STAFF RECOMMENDATION
1612 Lillian Street
January 20, 2016

Application: New construction-addition
District: Lockeland Springs-East End Neighborhood Conservation Zoning Overlay
Council District: 06
Map and Parcel Number: 08314023200
Applicant: Rich McCoy, rem3studio@att.net
Project Lead: Paul Hoffman, paul.hoffman@nashville.gov

<p>Description of Project: Construction of a one thousand, three hundred and forty-four square feet (1,344 sq. ft.). rear addition to a contributing historic home.</p> <p>Recommendation Summary: Staff recommends approval of this application, with the conditions:</p> <ol style="list-style-type: none">1. Staff approve the roof color, windows and doors prior to purchase and installation;2. The HVAC shall be located behind the house or on either side, beyond the mid-point of the house. <p>Staff finds that the addition meets the design guidelines for the Lockeland Springs-East End Neighborhood Conservation Zoning Overlay.</p>	<p>Attachments A: Photographs B: Site Plan C: Elevations</p>
---	--

Figure 1. 1612 Lillian Street

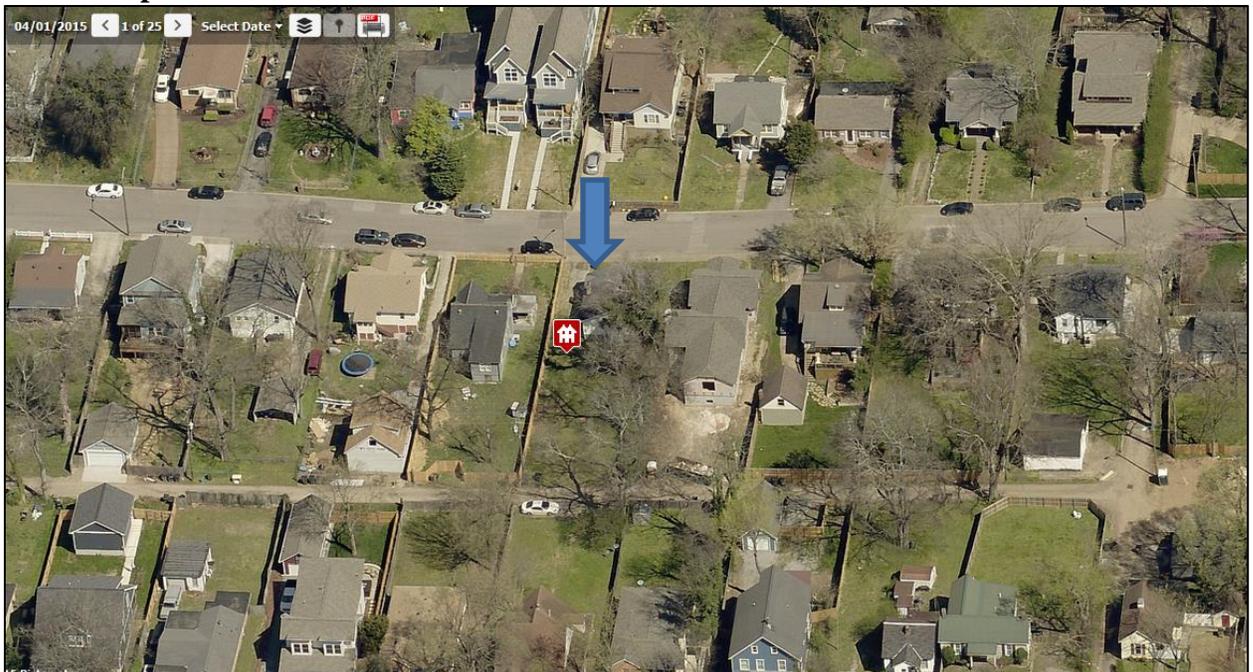
Background: 1612 Lillian Street is a contributing building in the Lockeland Springs-East End overlay. It was built circa 1930.

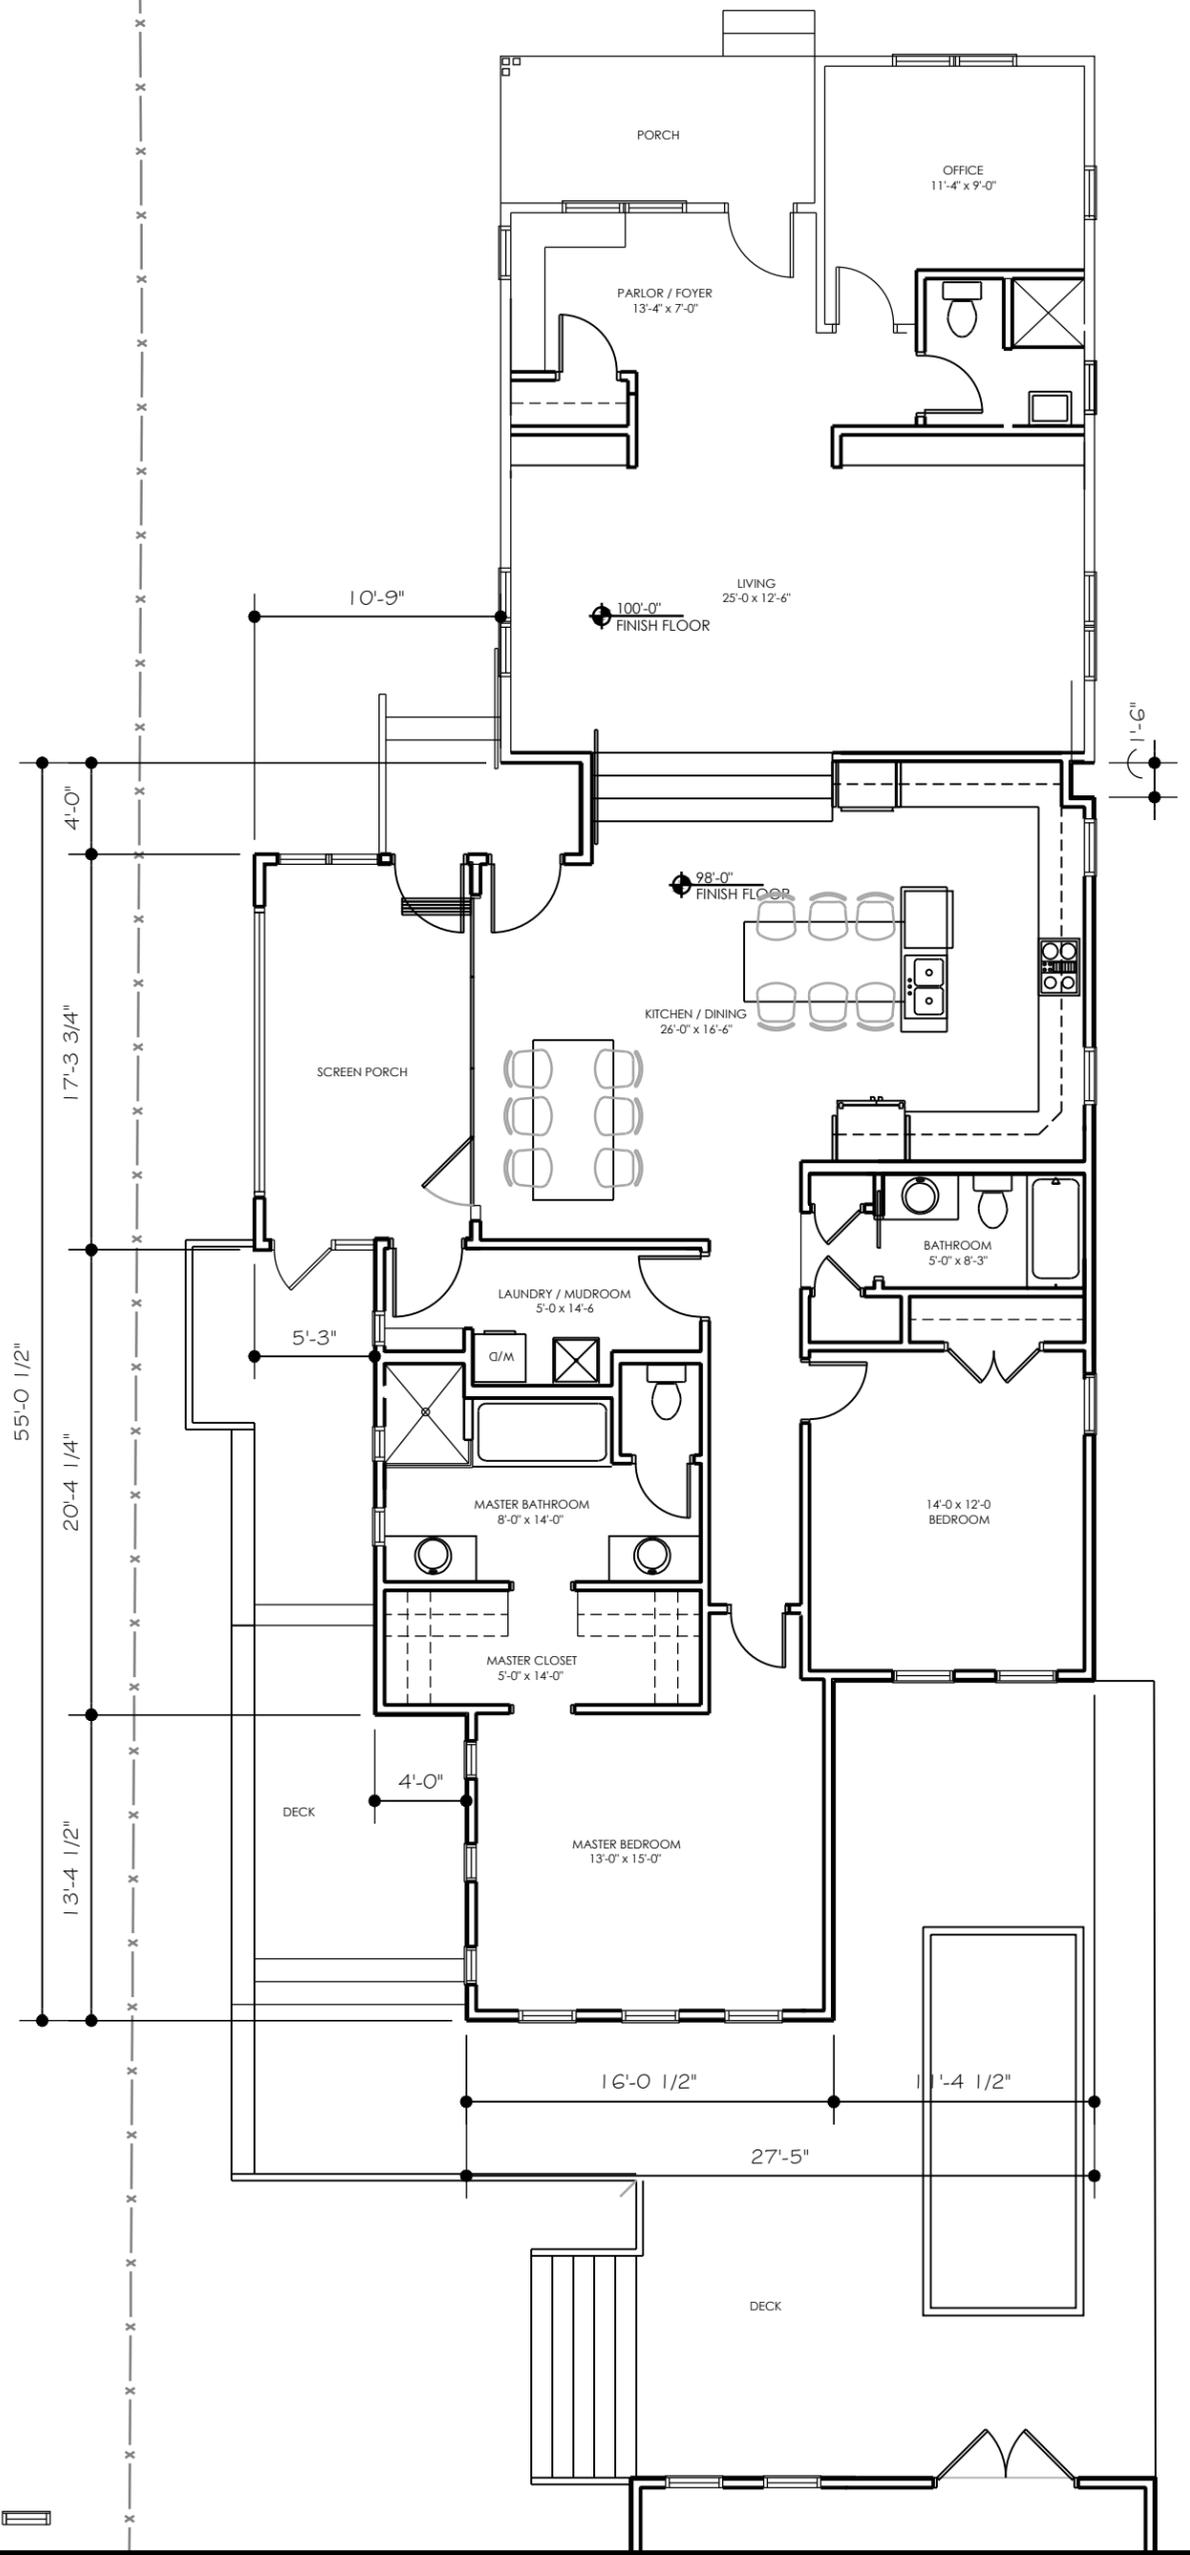
Height & Scale: The addition's height is the same as the existing height of the house. The proposed eave height and foundation height match those of the house. To the rear of its insets, the addition's width is ten feet, nine inches (10'9") wider than the house. Staff finds the added width to be acceptable in this case, as the historic building is very narrow, at only twenty-six feet (26') wide, and is also offset on the lot. In addition, the wider portion is thirty-five feet (35') back from the front wall of the house. It is approximately two feet (2') shorter than the ridge of the historic home, is less than half the width of the house and is a screened porch. All these factors together will minimize the massing of the addition in terms of its effect on the historic house.

The footprint of the proposed addition is approximately one thousand, three hundred and forty-four square feet (1,344 sq. ft.). The footprint of the existing house is eight hundred and seventy-seven square feet (877 sq. ft.) The proposed added length is fifty-five feet (55') tapering to the rear. In the past, the Commission has discouraged additions that more than double the size of the home. In this case the square footage is appropriate because of the extremely small size of the existing house, a portion of the addition is an open porch, and because the addition is not taller and for the most part, sits within the shadow line of the existing house, Staff finds the square footage to be compatible with the historic building. Staff finds that the proposed addition will meet section II.B.1 and II.B.2 for height and scale.

Setback: The side setbacks are seven feet (7') on the left and right sides. The rear setback is proposed at forty-four feet (44'). The project's setbacks meet bulk zoning and are appropriate for the historic home. The project meets section II.B.3.

Materials: The addition will be clad in smooth-faced cement fiberboard with a five inch (5") reveal. The trim will be wood or fiber cement. The screen porch will have cement fiber board-and-batten. The foundation will be split-faced concrete block, and the roof will be composite shingles. The windows will be wood. The deck at the rear of the addition will be pressure-treated wood framing and decking. Staff requests final approval of the roof color and windows and doors prior to their purchase and installation. With this condition, the known materials meet section II.B.4 and II.B.10.e.

Roof form: The addition's roof is a gabled form with 5/12 pitch. The screened porch has a gabled roof to the side with the same pitch. The roof form is common in the district, and the project meets section II.B.5.

Proportion and Rhythm of Openings: The windows on the proposed addition are generally twice as tall as they are wide, meeting the historic proportions of openings. There are no large expanses of wall space without a window or door opening. The project meets section II.B.6 for proportion and rhythm of openings.

Appurtenances & Utilities: The location of the HVAC and other utilities was not noted. Utilities should be located on the rear façade, or on a side façade beyond the midpoint of the house, to meet section II.B.9 of the design guidelines for minimal visibility of utilities.

1. Staff approve the roof color, windows and doors prior to purchase and installation;
2. The HVAC unit and other utilities be located behind the house or on either side, beyond the mid-point of the house.
